CALIFORNIA WATERFIX HEARING
California Department of Water Resources and U.S. Bureau of Reclamation
 The Public Hearing scheduled to commence on **Thursday, April 7, 2016**

PROTEST– PETITION

**PETITION FOR CHANGE in water rights of the Department of Water Resources and
 U.S. Bureau of Reclamation for the California WaterFix Project¹ _**

**Elliot/Stillwater Orchards
Water Rights Injuries
from CWF Tunnels**

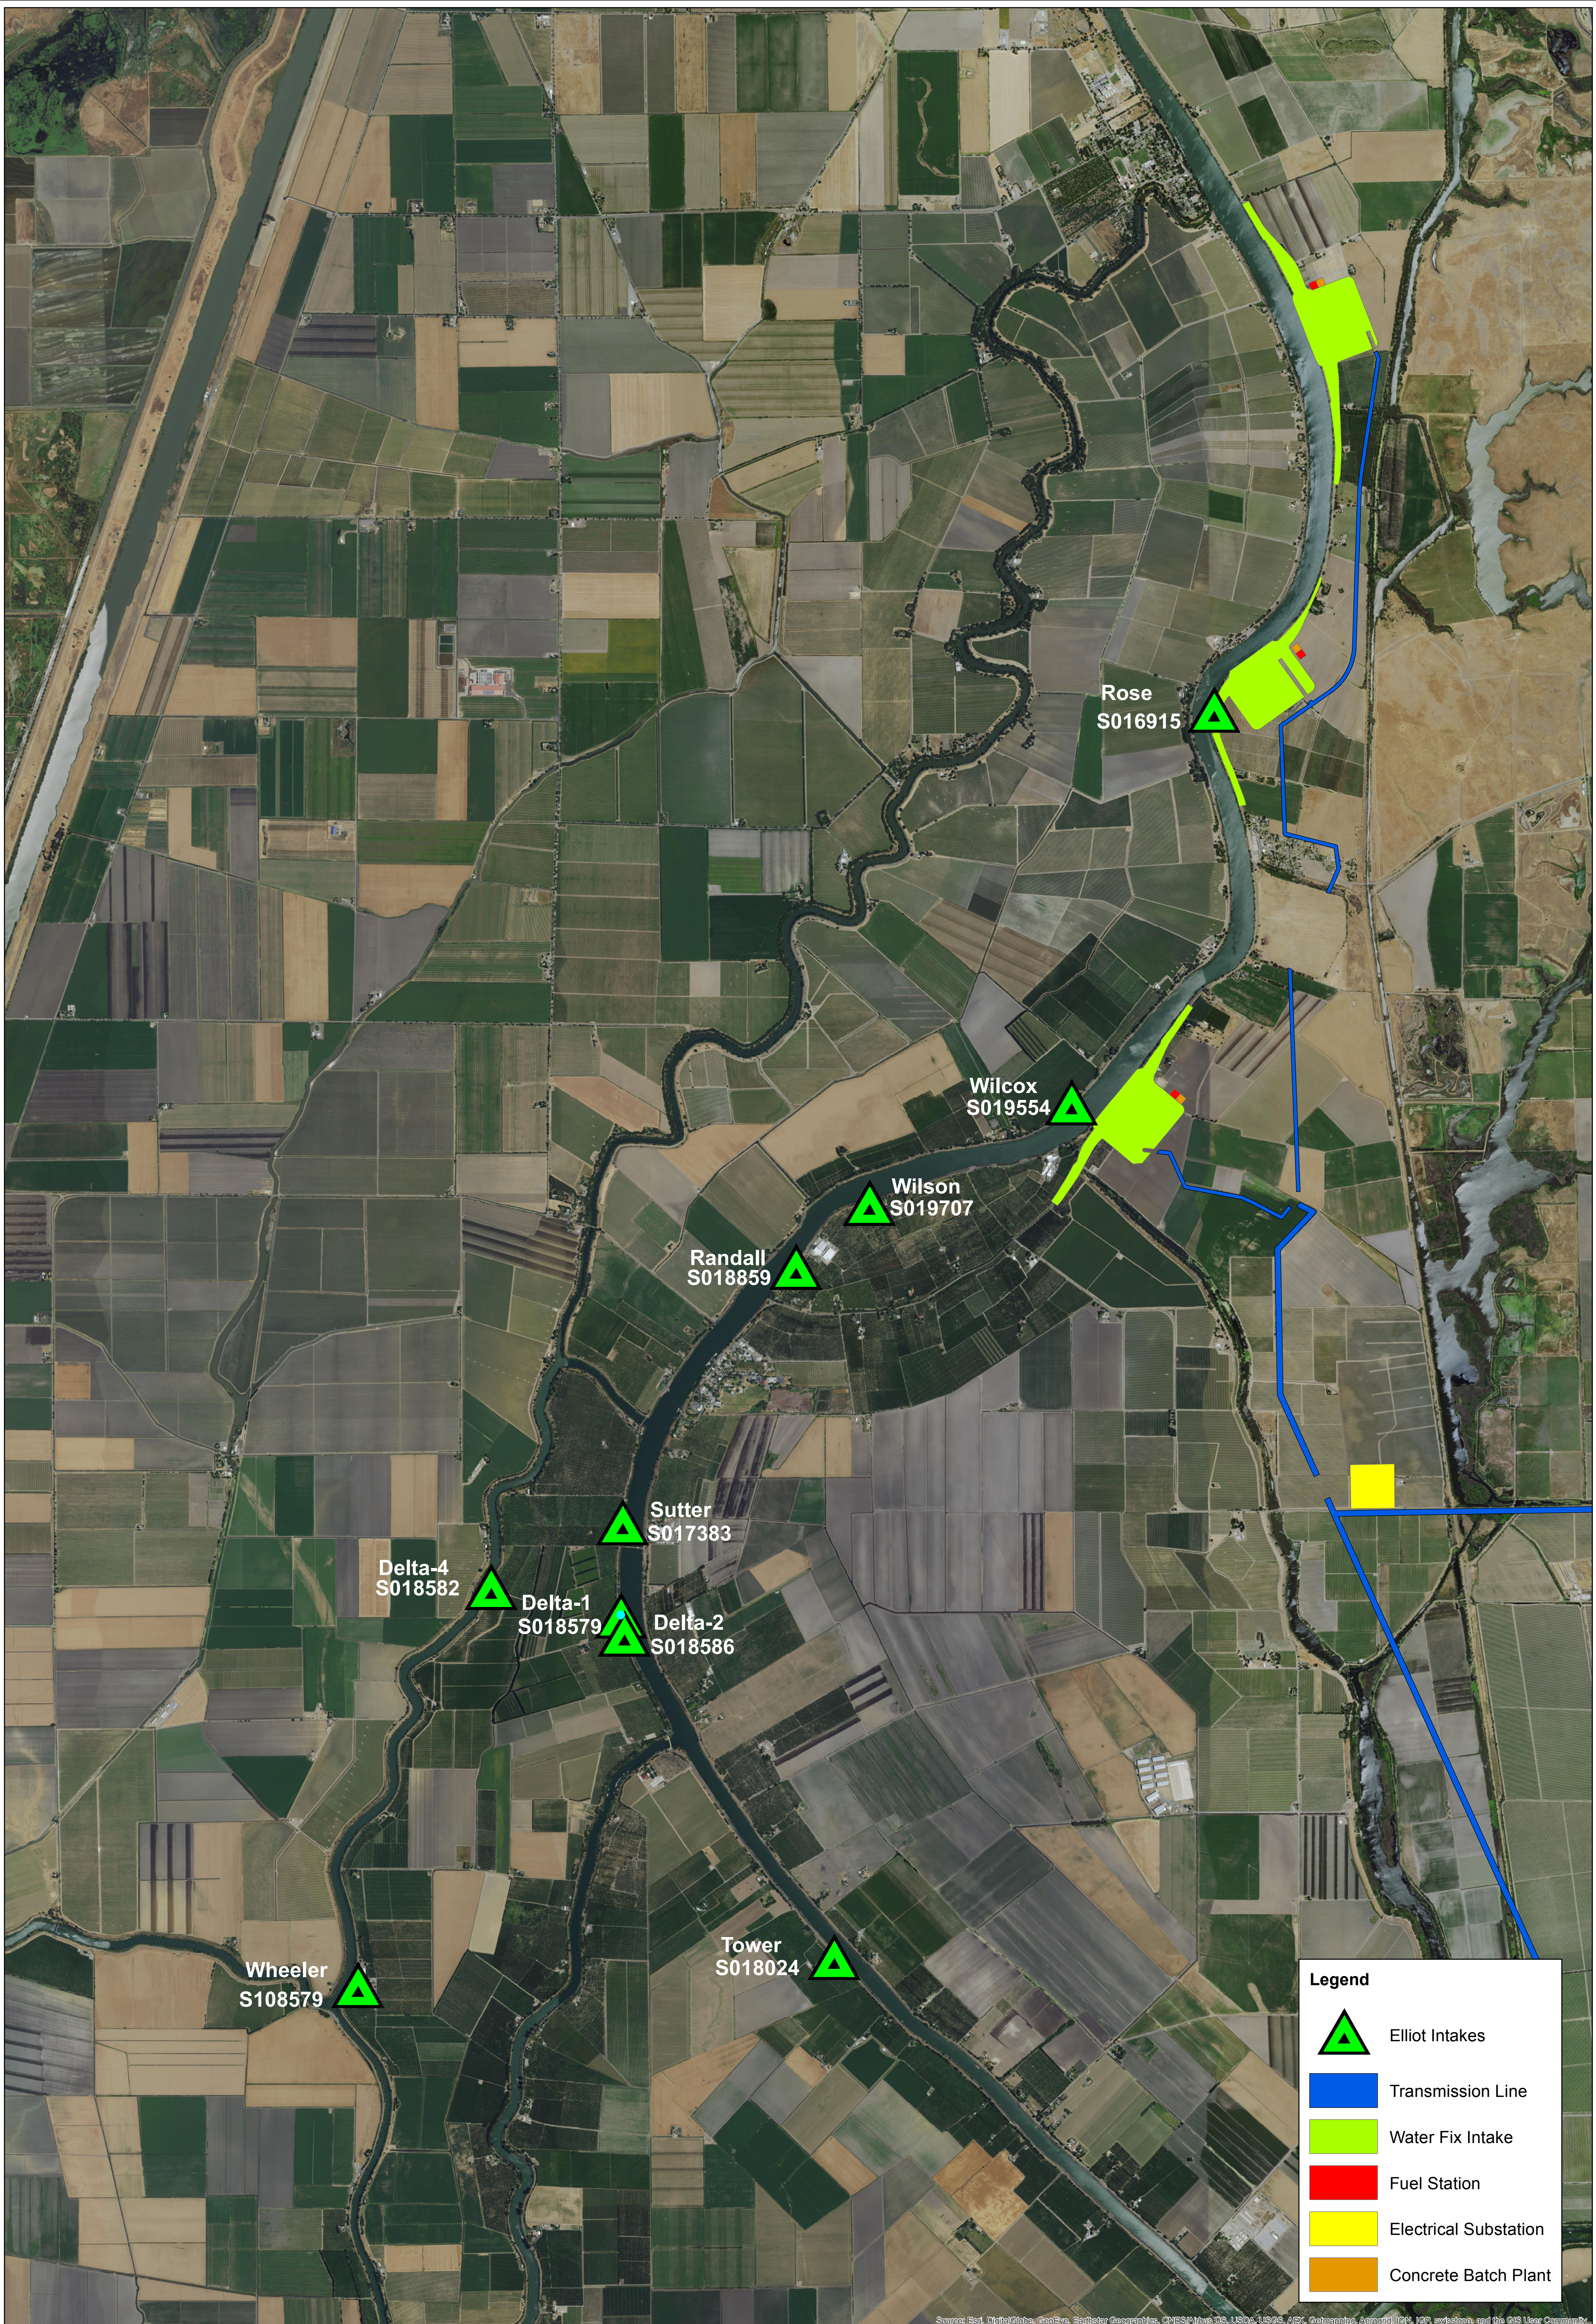
The explanation in the Petition of how water level changes would not constitute an injury is insufficient. (Petition, p. 21.) The brief description includes no citation to relevant authority nor does it defend the use of average water levels to describe what will be an impact to other water users in real time. Here, the protestant owns diversions that may be within the vicinity of the CWF Tunnel intakes and would be subject to water level changes constituting an injury. (See Exhibit B.)

Destruction of Protestant Elliot/Stillwater Orchards’ Diversion – As shown in Exhibit B, the middle intake for the proposed CWF Tunnels is located on top of one of Protestant Elliot/Stillwater Orchards’ Diversion. Moreover, the orchard irrigated by that Elliot/Stillwater Orchards intake is listed as a parcel that the Petitioners plan to take by eminent domain in order to construct the Tunnels project. The destruction of the Elliot/Stillwater Orchards diversion and the taking of all or part of the orchard served by it constitutes an injury to Elliot/Stillwater Orchard’s legal water rights.
